PLANNING REPORT

Architectural Review Board

Riverview Village - 62 N. Riverview Street Demolition-Landmark and AFDP 26-057ARB-DEMO and 26-058ARB-AFDP

Case Summary

Steps Carved into Bedrock

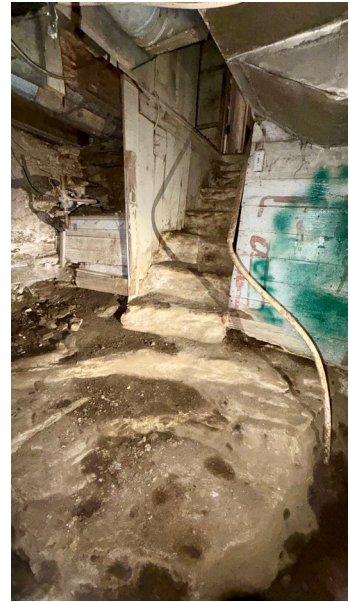
The existing structure is representative of the evolution of Dublin's early years when the riverfront was populated by industrial uses that supported the surrounding small village. While the structure itself was most recently used as a single-family house, its stone foundation might have supported other uses in the past, especially since it does not extend to the full depth of the existing structure. This foundation is built into and rests on the bedrock, which creates an interesting juxtaposition of the natural and built environments. In fact, an interior set of steps leading to the lowest level is carved into that bedrock. The wood structure above has also evolved over time, but the essential mass and character have remained the same since at least 1929 as evident in historic photographs. The applicant's plan has always been to restore it and adapt it to a new use that would rejuvenate the historic riverfront. For those reasons, the recent discovery of the severe deterioration of its structural integrity is quite unfortunate. While parts of the building could conceivably be renovated, this would virtually involve reconstruction of much of the structure regardless. Removal of the water infiltration source and restoring/tuckpointing the foundation walls might also be possible, but both the structural engineer and the Chief Building Official are concerned about their stability once the use changes from single-family residential to a more intense use.

While interior features are outside of ARB's purview, staff also recommends that the applicant make a good faith effort to work around/retain the carved stone steps at the lowest level.

- 1) That the foundation wall stones be salvaged and reused as a veneer on the exterior of the new foundation walls.
- 2) That the stone on the front chimney be salvaged and reused in the new replica chimney.
- 3) That the arched window on the front façade be salvaged and reused as part of the interior décor or elsewhere within the overall development site.
- 4) That any windows, doors, or interior wood siding that are in reasonably good condition be salvaged and reused as part of the interior décor or offered to charitable organizations or architectural salvage companies.
- 5) That the applicant make a good faith effort to retain and work around the existing carved stone steps at the lowest level of the structure.

Stone Foundation Wall

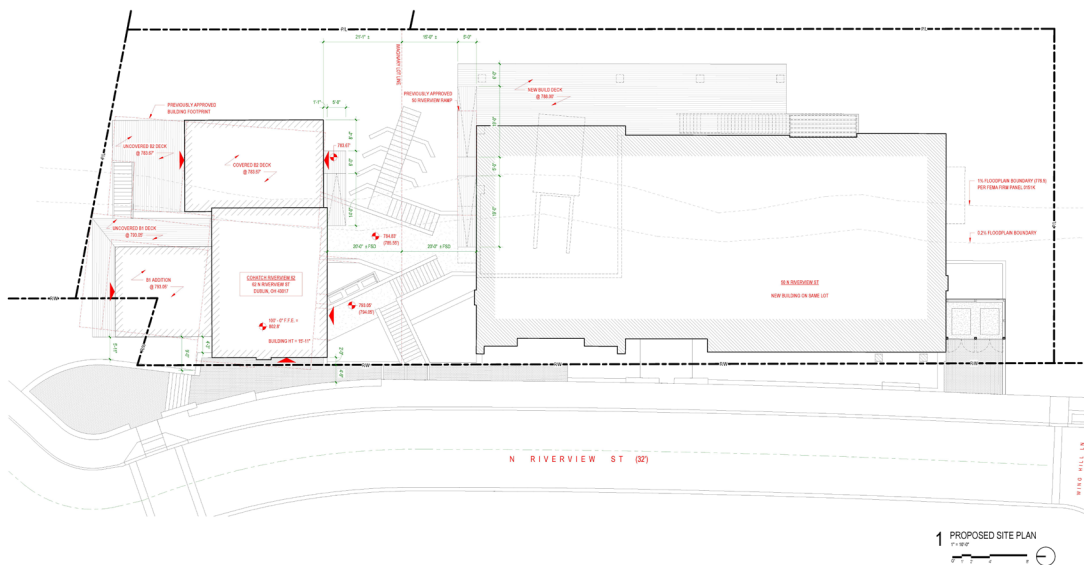
Based on the structural analysis and the Chief Building Official's conclusion, staff recommends approval of the demolition request. However, in order to preserve some of the historic fabric and help achieve the intent of §153.176(J)(4), staff recommends that the following items be salvaged and reused to the extent feasible.

- The stone foundation walls to be used as a veneer on the exterior of the new foundation walls.
- The stone on the front chimney to be reused on the new replica.
- The arched window on the front façade (given its association with the adjacent historic foundation walls). It could conceivably be used as part of the interior decor or elsewhere within the overall development site.
- Any windows, doors or interior wood siding that are in reasonably good shape, which could be used within the structure or otherwise offered to organizations such as Habitat for Humanity or architectural salvage companies.
